Chairman Joseph Lupia
Town of Manlius Planning Board
March 29, 2023

As you know, Cypress Creek appeared before the Planning Board on February 13, 2023, with respect to certain field changes to a solar facility previously approved on May 23, 2022. At that meeting, the Planning Board requested that we provide a more detailed explanation as to the feasibility of converting the POI electric pole-line up into underground wiring given the proposed reduction in pole-to-pole distance from 50ft to 40ft. Please allow this correspondence to serve as a response to the Planning Board’s concerns raised at that meeting.

On May 23, 2022, the Town of Manlius Planning Board issued a Site Plan Approval decision to Meltwater Solar, LLC. Drawings submitted as part of Meltwater’s application had assumed the following “Point of Interconnection” or “POI” design:

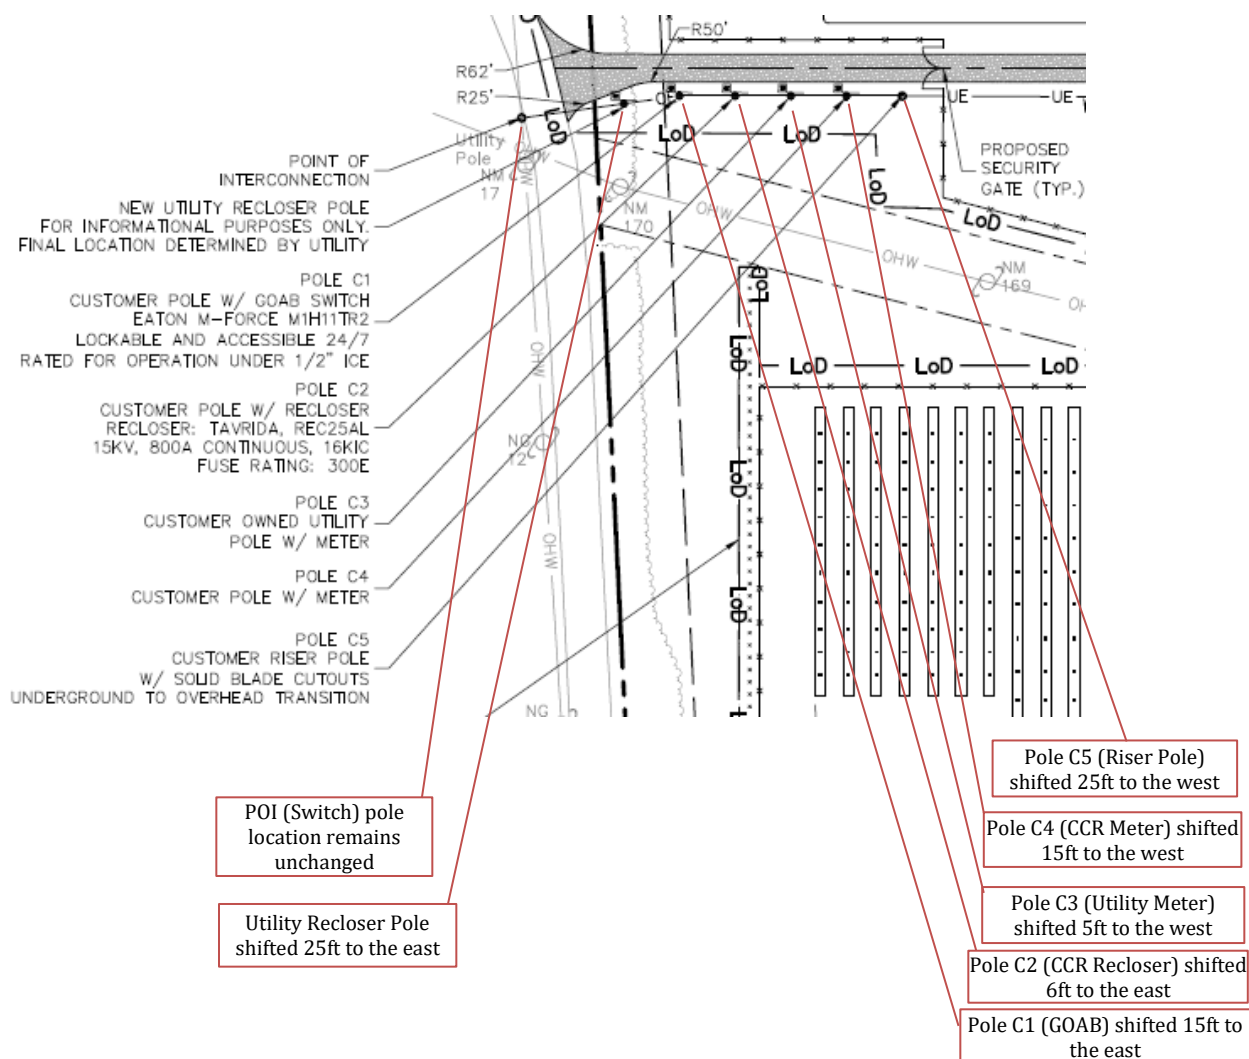
On July 19, 2022, Meltwater Solar, LLC conducted a site visit with National Grid representatives to confirm final locations for the POI installation. This site visit instead resulted in Meltwater Solar, LLC receiving the following feedback from the utility:

1. National Grid will set a midline pole across the street to feed the site. Note: Should this pole/anchor need to be placed on 3rd party property, the developer will be responsible to obtain the easement/ROW.

2. The pole line up needs to be a minimum of 10 feet off the access road.

3. National Grid Recloser pole location TBD. National Grid wants to make sure this pole is on the developer's property as well as outside the swale and requires the following:

a. Developer is going to locate the existing town ROW from centerline on street to their property.

b. Once National Grid determines the location of the recloser pole, all poles after that pole will be 50 feet apart.

a. Developer will update the site plan to incorporate this distance.

4. Developer to resubmit site plan with changes for review.

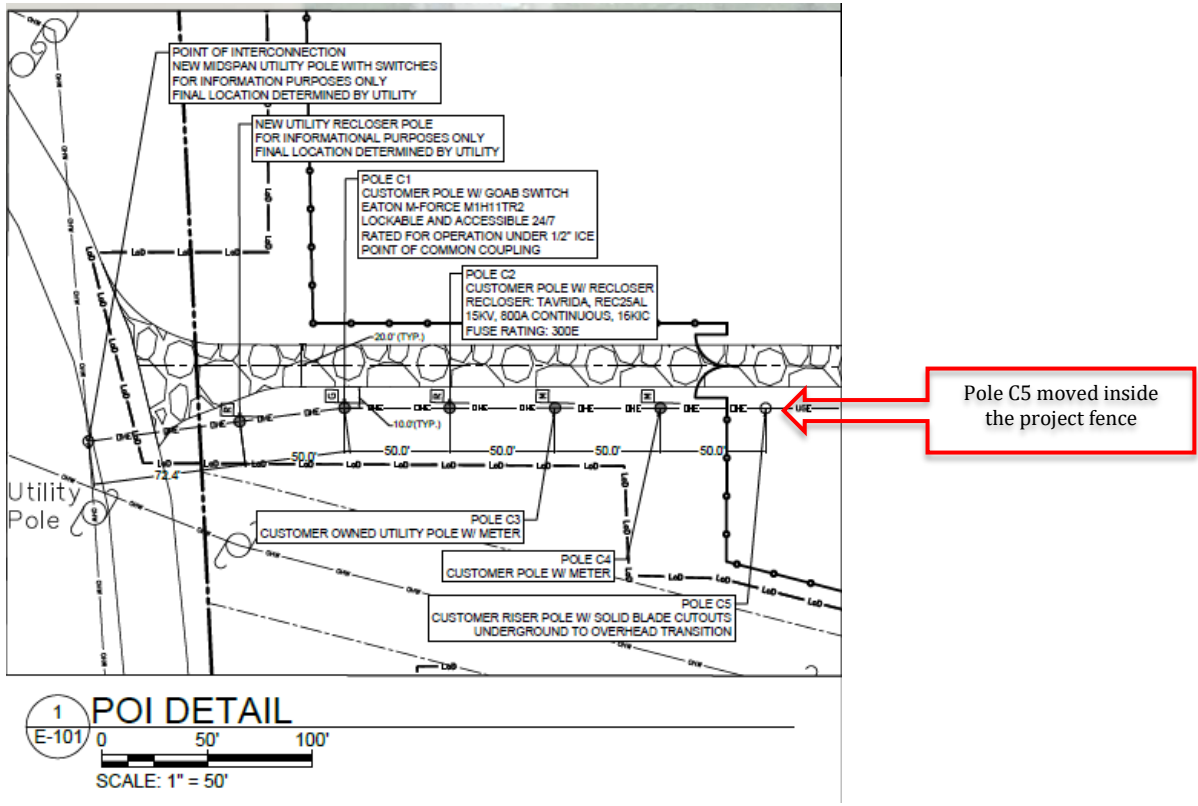
On October 12, 2022, Meltwater Solar, LLC submitted a revised site plan (POI diagram shown below) to National Grid, which was subsequently accepted and approved for the development of a utility easement ahead of construction.

Note: Because Point #3a required shifting the utility recloser pole 25ft to the east to avoid the town ROW, there was not enough room between the first pole in the POI lineup and the project fence. As a result, the pole-to-pole spacing for the six poles to the east of Kirkville Rd was reduced from 50ft to 40ft. National Grid was accepting of this change given the site constraints (see separate attachment for email confirmation).

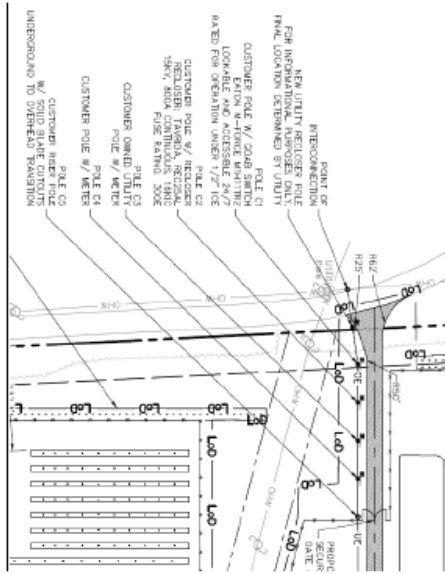
Proposed Solution: Given the above considerations, Meltwater Solar, LLC proposes restoring the 50ft pole-to-pole distance that was originally approved by the Planning

Board. This can be achieved by moving Pole C5 inside the fence and moving eastward the remaining poles to the east of the Utility Recloser Pole, as shown below. This would mitigate the aesthetics concerns prompted by the revised POI design presented at the February 13, 2023 meeting, while still adhering to National Grid’s requirement to move the Utility Recloser Pole outside of the ROW.

Meltwater Solar, LLC respectfully requests that the Town of Manlius Planning Board consider all the above factors and allow for the project to proceed with this newly revised POI design.

Appendix A

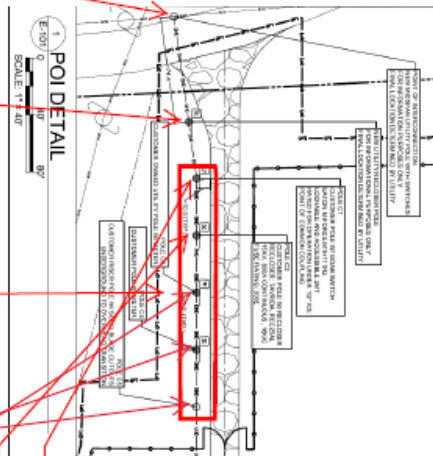
POI pole location remains unchanged.

Utility Reducer Pole location has shifted 25 ft in the eastward direction.

Pole-to-pole spacing for these five remaining poles has changed from ~50ft to ~40ft

- Pole C1 has shifted 15 ft in the eastward direction.
- Pole C2 has shifted 0 ft in the eastward direction.
- Pole C3 has shifted 5 ft in the westward direction.
- Pole C4 has shifted 15 ft in the westward direction.
- Pole C5 has shifted 25 ft in the westward direction.

Note - all poles remain within the original, PB-approved "Limits of Disturbance" or "LOD" boundary (as shown in each excerpt)
